**MASTER DEVELOPMENT DRAINAGE PLAN FOR  
LOT 1177 WOODMEN HILLS FILING #10  
EL PASO COUNTY, COLORADO**

**MAY 2020**

SKP-20-003

# MDDP\_v1\_redlines.pdf Markup Summary

### PROPOSED DRAINAGE MAP

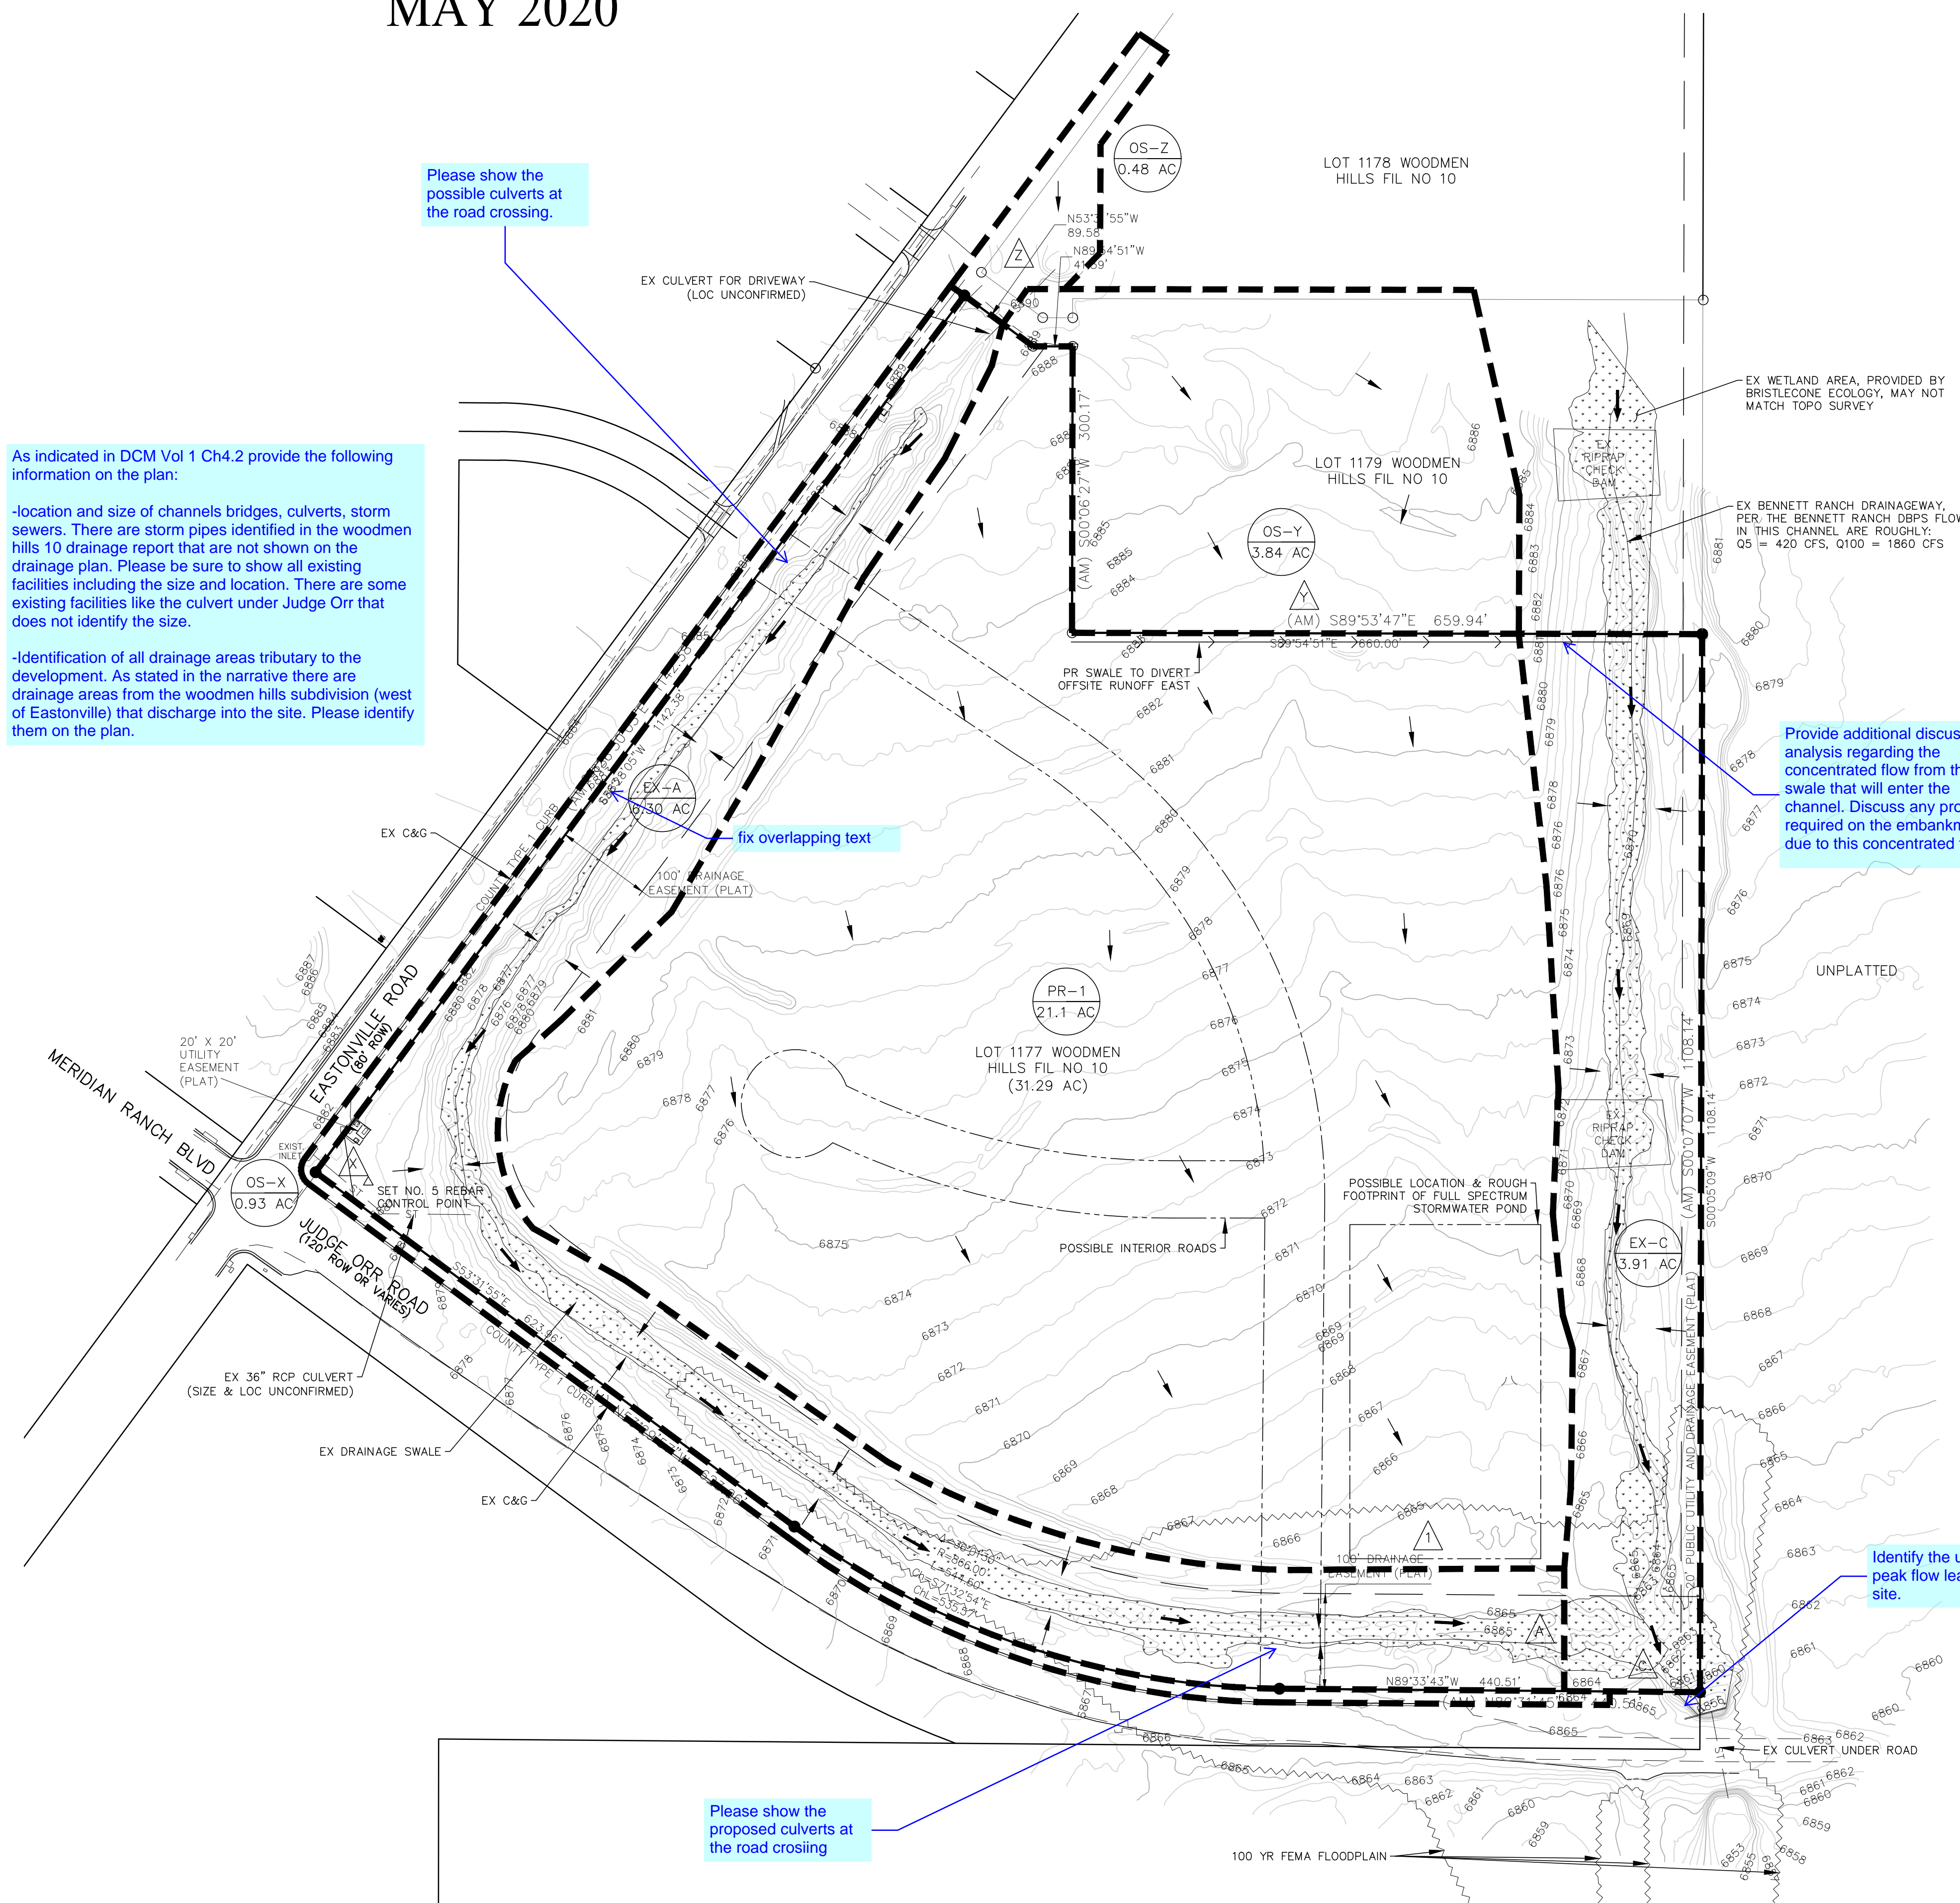
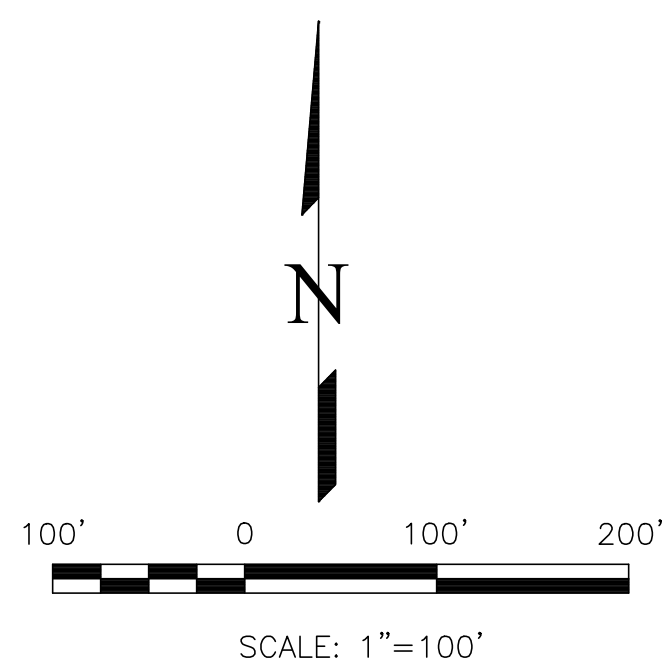
Please show the possible culverts at the road crossing.

As indicated in DCM Vol 1 Ch4.2 provide the following information on the plan:  
 -Location and size of channels bridges, culverts, storm sewers. There are storm pipes identified in the woodmen hills 10 drainage report that are not shown on the drainage plan. Please be sure to show all existing drainages including the size and location. There are some existing facilities like the culvert under Judge Orr that does not identify the size.  
 -Identification of all drainage areas tributary to the development. As stated in the narrative there are drainage areas from the woodmen hills subdivision (west of Eastonville) that discharge into the site. Please identify them on the plan.

fix overlapping text

Provide additional discussion & analysis regarding the concentrated flow from the swale that will enter the channel. Discuss any protection required on the embankment due to this concentrated flow.

Identify the ultimate peak flow leaving the site.

Please show the proposed culverts at the road crossing
